JOINT PLANNING COMMITTEE
UPDATE SHEET – 14 November 2018

WA/2017/2391

LAND SOUTH OF HIGH STREET BETWEEN ALFOLD ROAD AND KNOWLE LANE, CRANLEIGH

Proposed LAP layout and equipment (northern area of site)

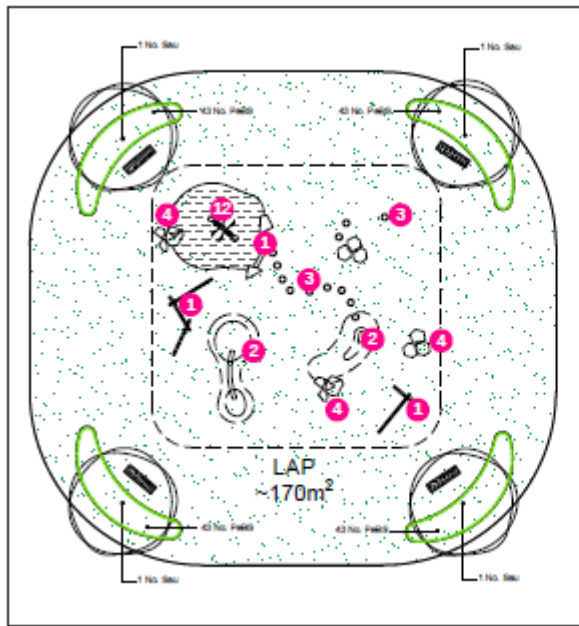
Officers have consulted with the Council’s Parks Project and Playspace Officer, who recommended some changes to the type of equipment and surfacing underneath the equipment. These changes have all been incorporated and, following review of the submitted information, the Council’s Parks Project and Playspace Officer considers the specification to be acceptable.
